Docket Item # 4  
BAR CASE # 2010-0073

BAR Meeting  
April 28, 2010

**ISSUE:** Alterations  
**APPLICANT:** Arthur Garden and Maribeth Monti  
**LOCATION:** 320 North Patrick Street  
**ZONE:** RB/Residential

**Figure 5. Front Elevation of 2008 Approval**

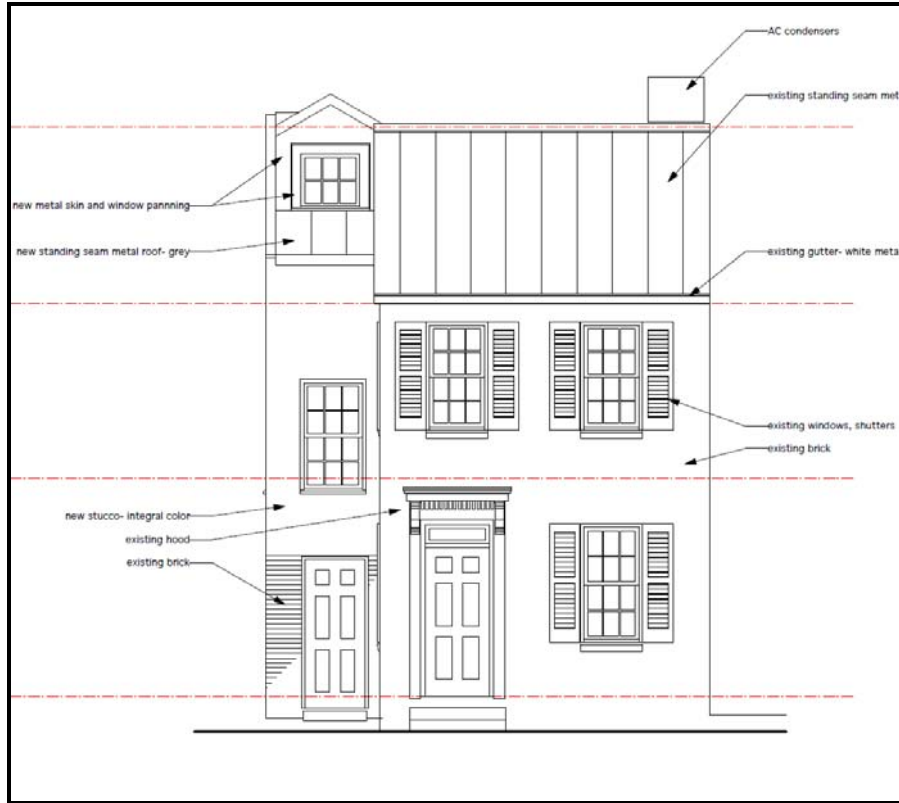
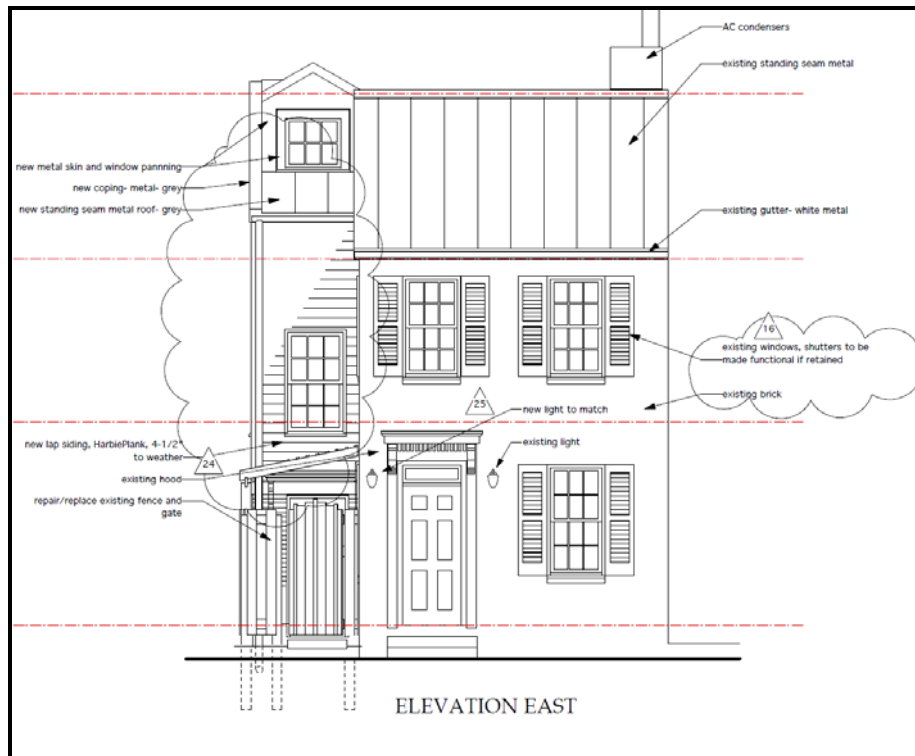
1. Change approved wall fabric from stucco to Hardi-plank 4-1/2" lap siding.
2. Repair and replace existing 6' high fence and gate

Figure 7. Carport - 2008 Approval

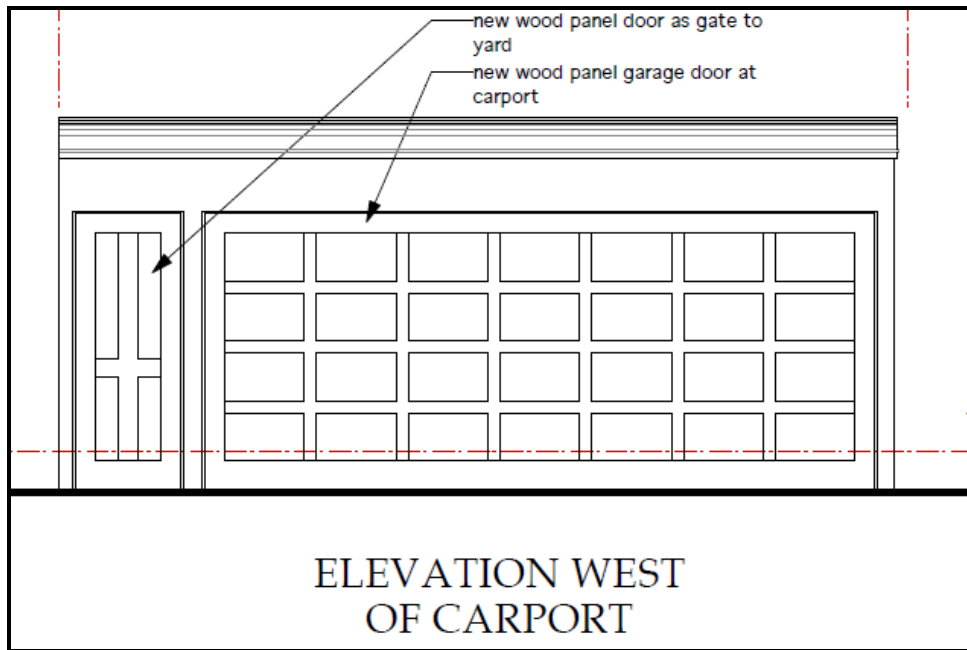
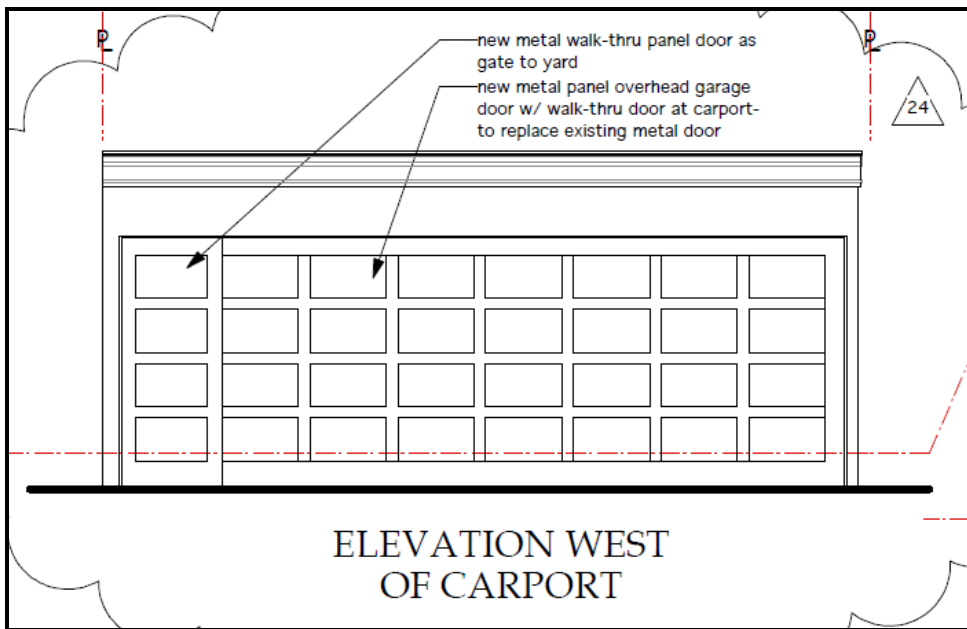
That the applicant provide manufacturer's specifications for the proposed new window and doors on the addition and carport for Staff to confirm that the window will be painted wood to match the details of the previously approved windows and that the metal garage doors be a smooth painted finish.

1. Replace approved wood, four-panel door with a new, horizontal four-panel metal door.
2. Replace approved wood, panel overhead garage door with a new, metal panel overhead garage door.

Figure 11. North (Side) Elevation – Current Proposal

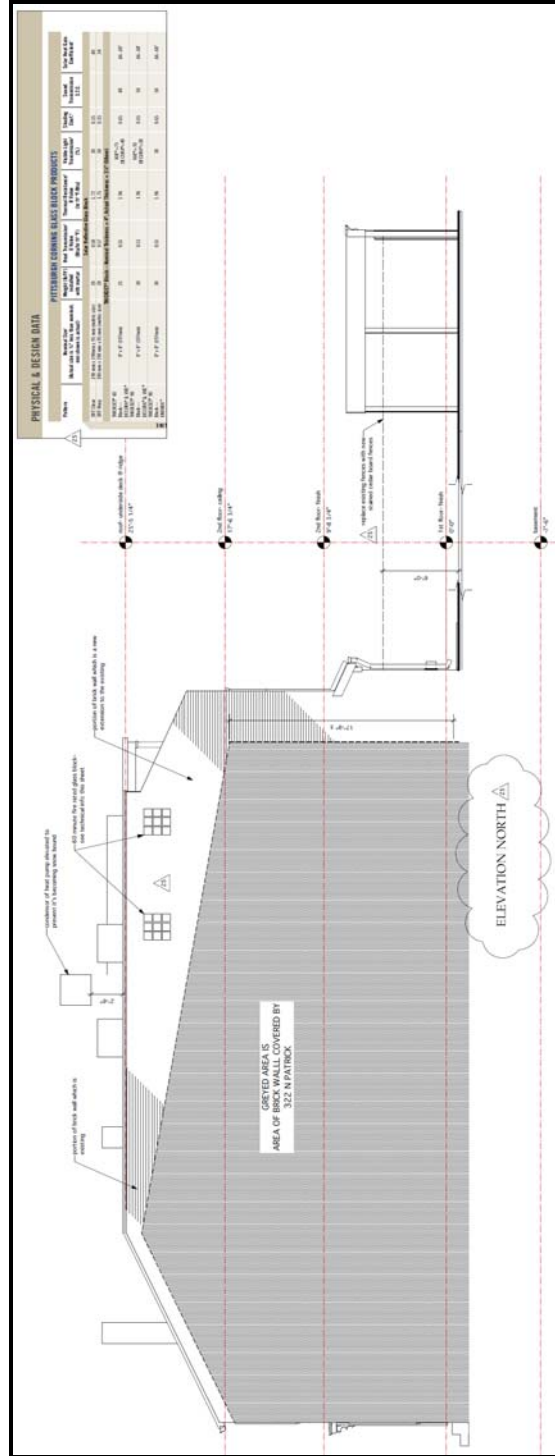
1. Install a new wood pergola over existing side walkway.
2. Install metal gooseneck flues on the roof for the boiler and water heater.
3. Remove existing non-operable wood shutters and replace with operable wood, two panel louvered shutters.
